Office Action Summary

10/617,171

Final Rejection

1. Claims 1-23 are rejected under 35 U.S.C. 102(e) as being anticipated by Takashima (US 6,787,941).

FIG. 8 Prior Art

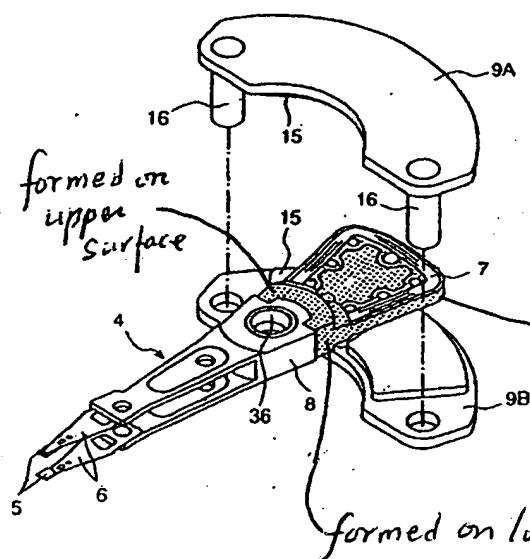
Claims 1, 5, 6, 10, 11, 15, 16, and 20; Takashima shows an actuator of a hard disk drive in Fig. 1, having a base plate and a voice coil motor, to move a magnetic head to record and reproduce data with respect to a disk to a predetermined position on the disk, including: and Fig. 8 shows a suspension 6 supporting a slider 5, where the magnetic head is mounted; and an arm 8 included on the base plate of the hard disk drive to pivot, the arm including the suspension at a leading end portion of the arm and a coil 7 (Fig. 8) of the voice coil motor coupled to a rear end portion of the arm, wherein the coil is coupled to the rear end portion of the arm by an outer mold (See Figs. 8 and 9 with added marks in next page) formed to encompass an outer circumference of the coil, an inner mold formed inside the coil, and a connection mold connecting the outer mold and the inner mold is formed at least part of a surface of a non-effective portion of the coil except for an effective portion arranged to be perpendicular to a direction in which the arm pivots.

FIG. 9 Prior Art

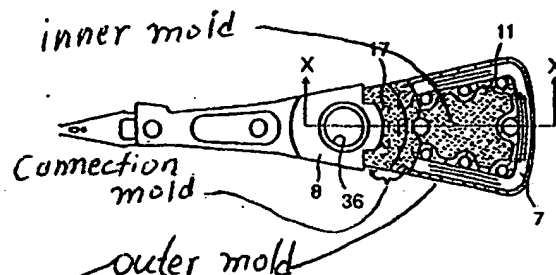
Applicant argues: "Figure 10 is cross-sectional view of Fig. 9. In Figure 10, the alleged 'outer mold' is the same pad as holding member 11 as the thin/thick stripes of the cross section show. That is, the alleged inner mold 11 is the same piece as the alleged outer mold. In this context, something is missing, either the inner or outer mold."

FIG. 10 Prior Art

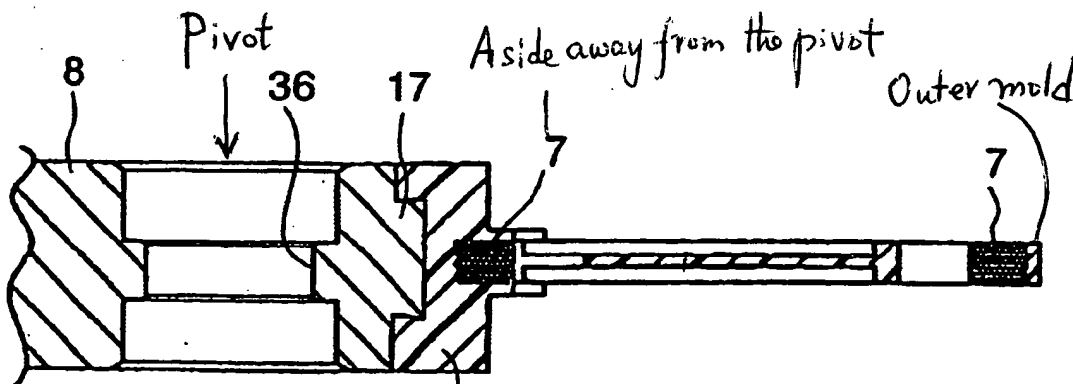
Claim 23, Takashima further shows in Fig. 10 attached in next page that the arm has a pivot, the coil has a side away from the pivot and the connection mold is located on the side away from the pivot.

Examiner's answer: Applicant misreads the figure. The correct way of reading Figure 10 is as follow:

Since Applicant's reading is incorrect, Applicant's argument is moot.
